Access Compliance Report Public Rights-of-Way (RR Crossings)

Intersection ID: 10025412	Main Street: E_CARSON_BV	Location: N/A
ADA ID: 7BE3A54E6827	Overall Compliance: No	Severity Score: 0.0
Codes/Mitigation Info/Possible Solution		Field Measurements/Component Compliance

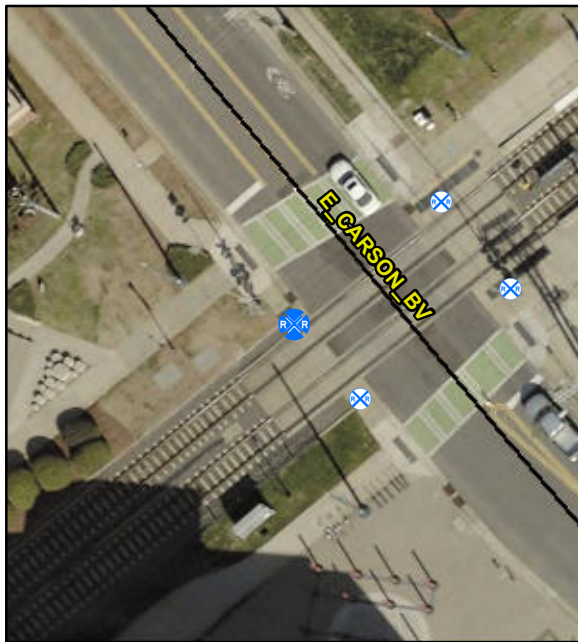
Compliance	Description	Data
Yes	DWS Provided?	Yes
Yes	DWS Contrast?	Yes
Yes	DWS Width (in)	Yes
Yes	DWS Length (in)	36.0
No	DWS Offset (in)	29.0
Yes	Pedestrian Gate?	Yes
N/A	DWS Outside Gate?	No
N/A	Rail Type?	LightRail
No	Flangeway Gap (in)	3.0
No	Sidewalk Width (in)	28.0

**Remove & Replace Detectable
Warning System. Remove & Replace
Walking Surface Adjacent to Rail.
Remove & Replace Sidewalk.**
